MECKLENBURG COUNTY
HEALTH DEPARTMENT

APPLICATION FOR A RESIDENTIAL SITE IMPROVEMENT PERMIT/ CONSTRUCTION AUTHORIZATION FOR AN ON-SITE WASTEWATER SYSTEM, NEW WELL INSTALLATION, OR REPAIR OF EXISTING WELL

Re: Application for improvement permit for: 3 Bedroom House
Property Location: Sam Wilson Rd Lot 13, Charlotte, NC 28214 (Potion of PID 053-222-04)
Health Department File Number: **10967B (App ID 12111)**

SOIL/SITE EVALUATION
for ON-SITE WASTEWATER SYSTEM

PROPOSED PLOT PLAN

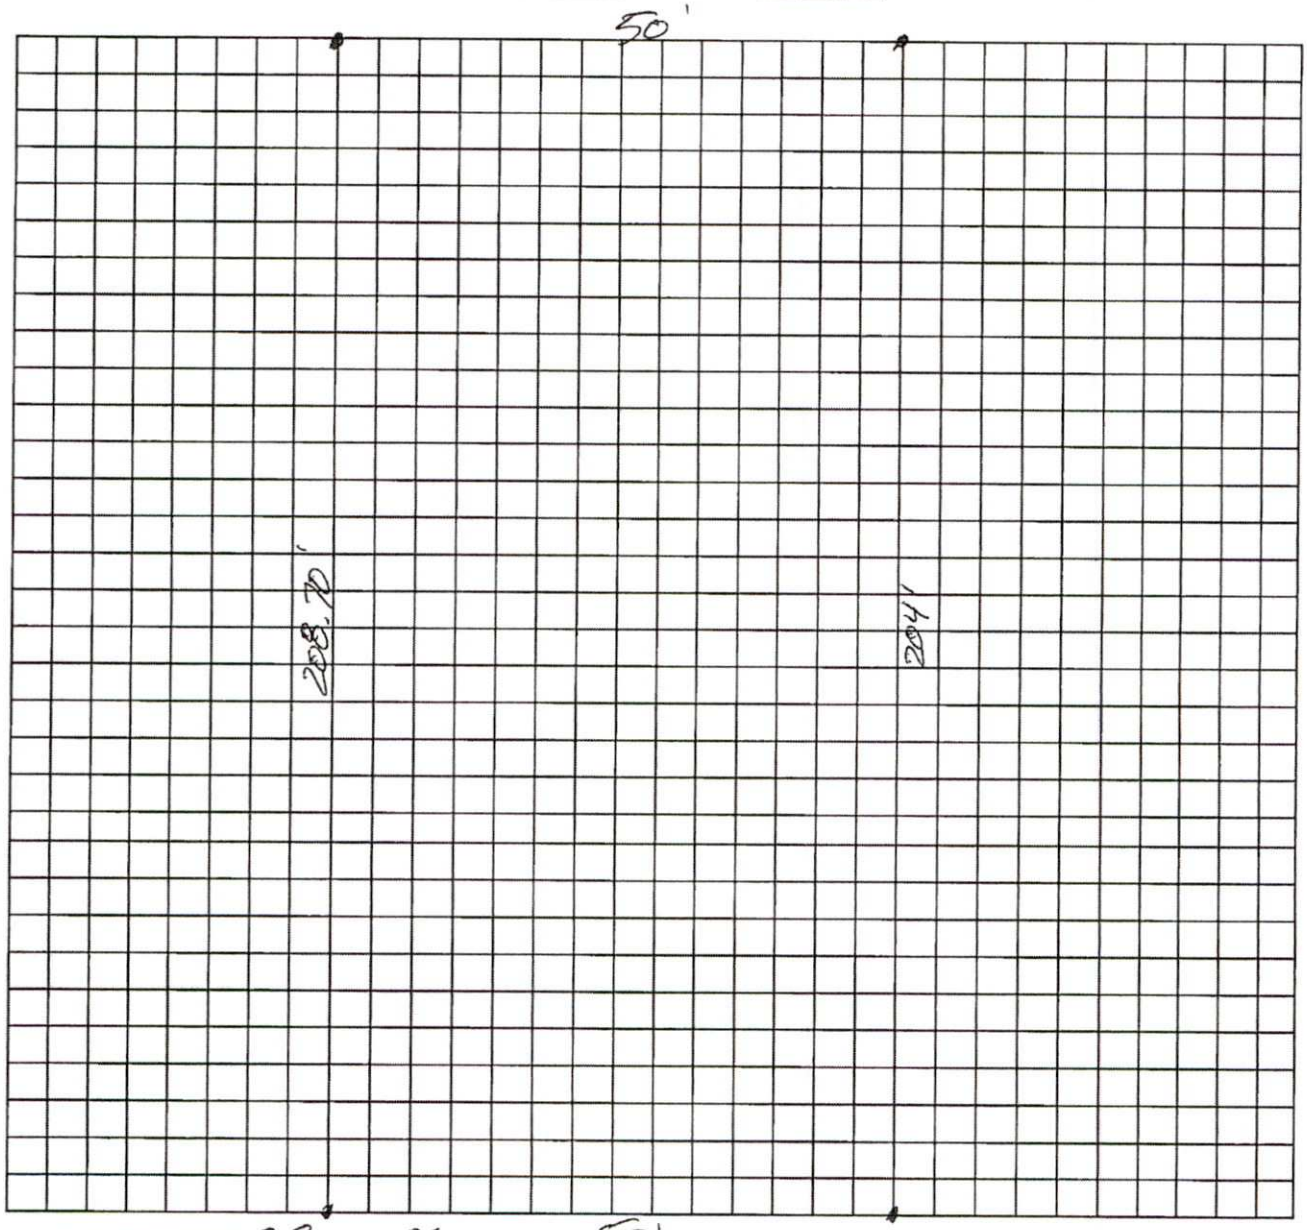
Based on the criteria set out in Title 15A, Subchapter 18A, of the North Carolina Administrative Code, Rules .1940 through .1948, the evaluation indicated that the site is **UNSUITABLE** for a ground absorption sewage system. Therefore, your request for an improvement permit is **DENIED.** A copy of the site evaluation is enclosed. The site is unsuitable based on the following:

- ☐ Unsuitable soil topography and/or landscape position (Rule .1940)
- ☐ Unsuitable soil characteristics (structure or clay mineralogy) (Rule .1941)
- ☐ Unsuitable soil wetness condition (Rule .1942)
- ☐ Unsuitable soil depth (Rule .1943)
- ☐ Presence of restrictive horizon (Rule .1944)
- ☒ Insufficient space for septic system and repair area (Rule .1945)
- ☒ Unsuitable for meeting required setbacks (Rule .1950)
- ☐ Other (Rule .1946)

For the reasons set out above, the property is currently classified **UNSUITABLE,** and an improvement permit shall not be issued for this site in accordance with Rule .1948 (c).

However, the site classified as **UNSUITABLE** may be classified as **PROVISIONALLY SUITABLE** if written documentation is provided that meets the requirements of Rule .1948(d). A copy of this rule is enclosed. You may hire a consultant to assist you if you wish to try to develop a plan under which your site could be reclassified as **PROVISIONALLY SUITABLE.**
